Title ANTI_ALIASING_FILTER - LEMO_VERSION		
Size A	Number D990147-A-C	Revision A
Date: 14-Mar-2000	Sheet of 2 of 33	Drawn By: SANDER LIU
File: C:\Temp\Antialis\Lemo\Sch\Daq-dif1.DDB

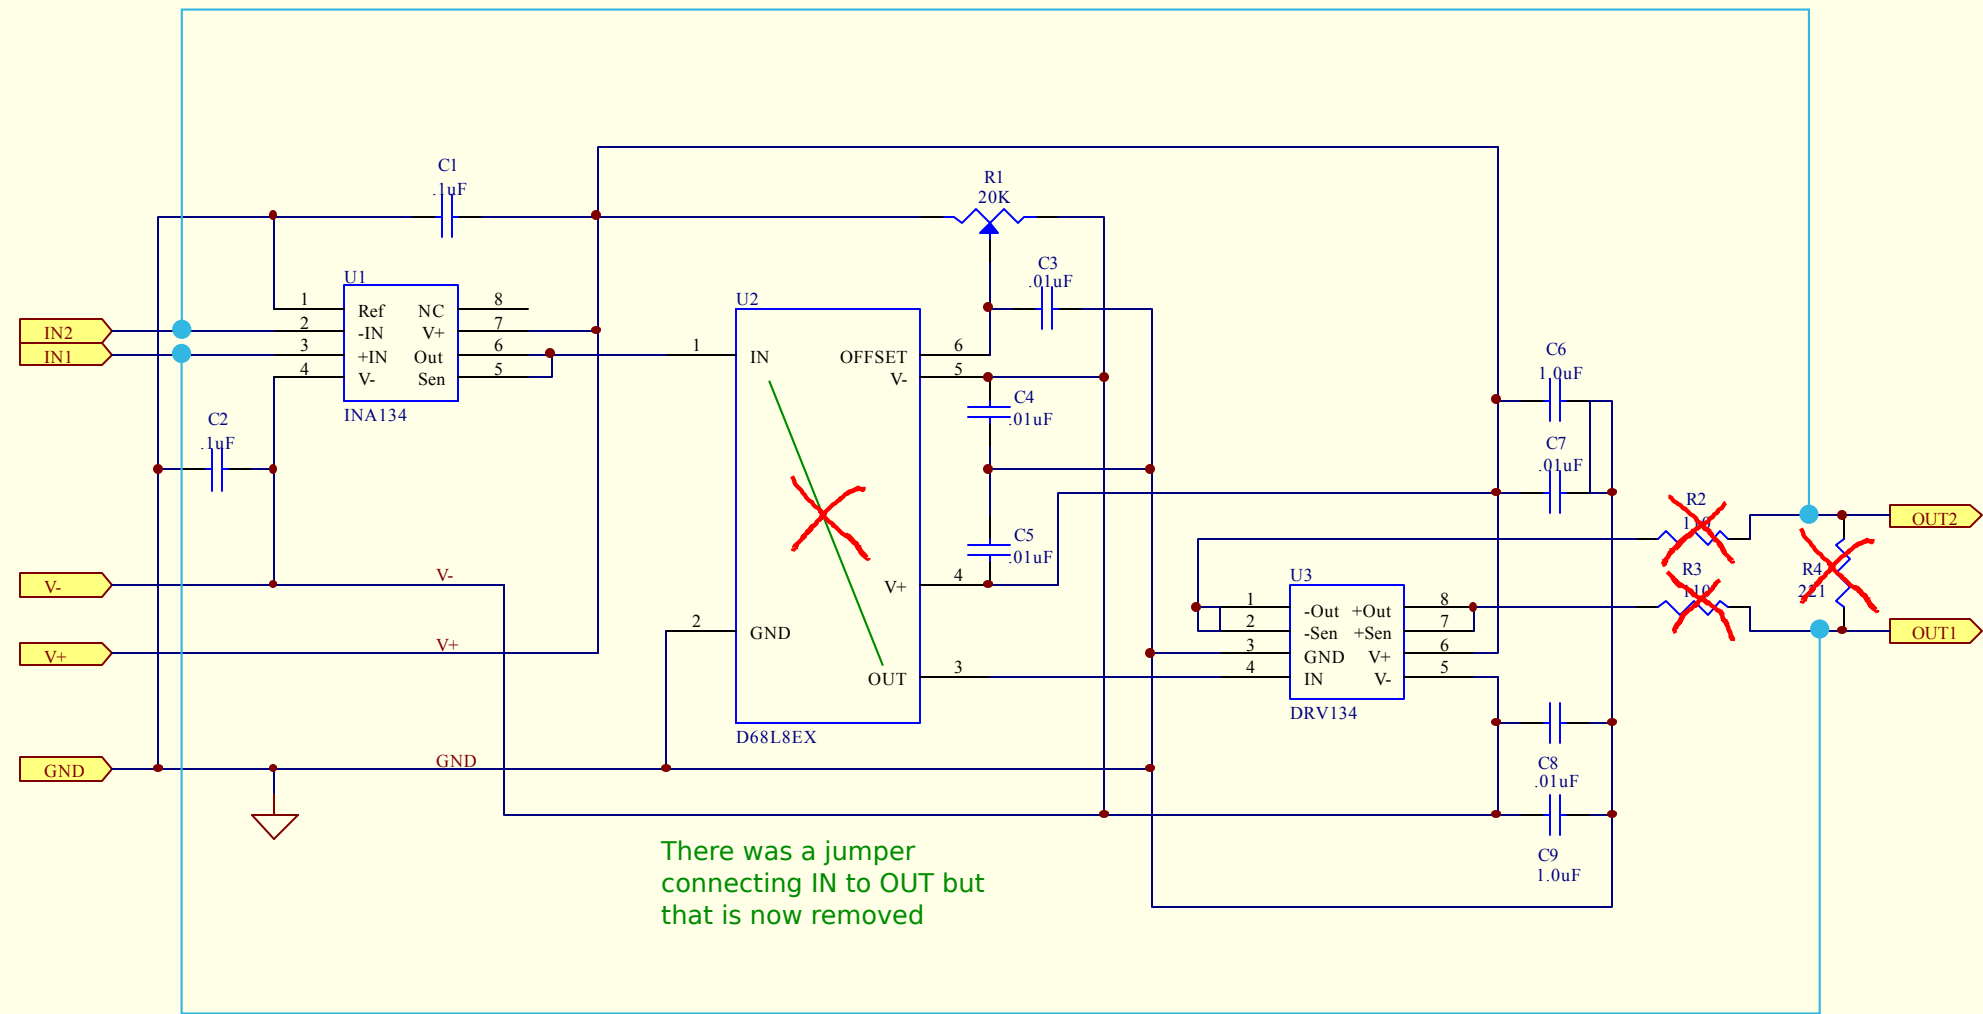
New connections

There was a jumper connecting IN to OUT but that is now removed
